**NPDES PERMIT FACT SHEET
ADDENDUM**

Application No. PA0000647
APS ID 804885
Authorization ID 964898

Applicant Name	<u>ATI Powder Metals LLC</u>	Facility Name	<u>ATI Powder Metals Robinson</u>
Applicant Address	<u>1000 Six PPG Place</u> <u>Pittsburgh, PA 15222</u>	Facility Address	<u>6003 Campbells Run Road</u> <u>Pittsburgh, PA 15205</u>
Applicant Contact	<u>Lauren McAndrews</u>	Facility Contact	<u>Lauren McAndrews</u>
Applicant Phone	<u>412-394-2974</u>	Facility Phone	<u>412-394-2974</u>
Client ID	<u>277125</u>	Site ID	<u>469559</u>
SIC Code	<u>3399</u>	Municipality	<u>Robinson Township</u>
SIC Description	<u>Primary Metal Products</u>	County	<u>Allegheny</u>
Date Published in PA Bulletin	<u>March 5, 2022</u>	EPA Waived?	<u>Yes</u>
Comment Period End Date	<u>April 4, 2022</u>	If No, Reason	<u>N/A</u>

Purpose of Application Application for a renewal of an NPDES permit for discharge of treated Industrial wastewater and stormwater.

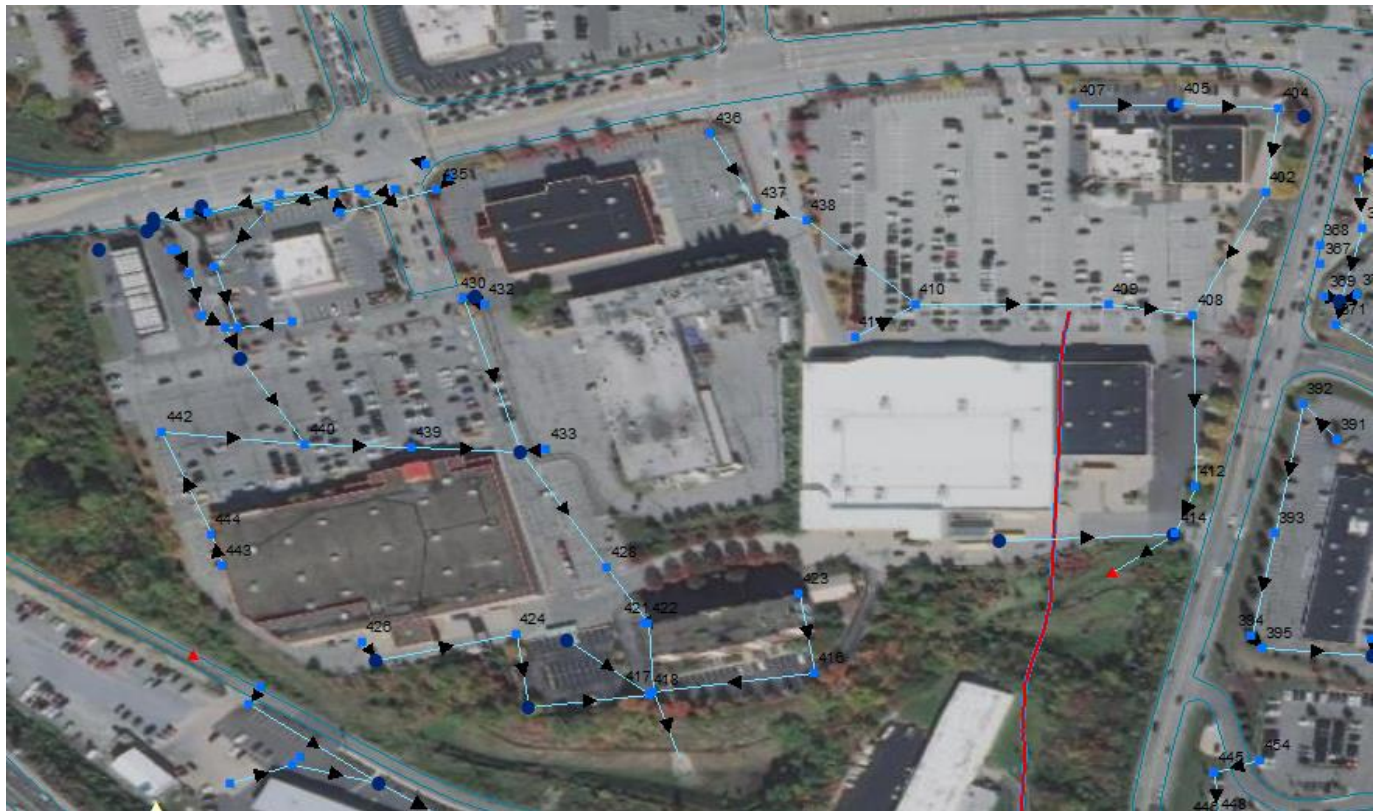
- 6) The draft permit specifies twice per month oil and grease sampling at Outfall 101, the same as the existing permit. We request this be reduced to 1/month or even once per quarter as we discussed. ATI had only one permit exceedance for this parameter at this outfall in the last several years. The source of that exceedance was found, and changes were made to remove the oil and grease source that caused the exceedance.

DEP RESPONSE: The frequency can be reduced to 1/month but will not be reduced to 1/quarter. Although the correction has been made to prevent a future recurrence, the presence of oil and grease as a pollutant of concern has been demonstrated and requires monitoring during this next permit cycle. The future renewal may consider a further reduction of sampling frequency if non-detections are maintained.
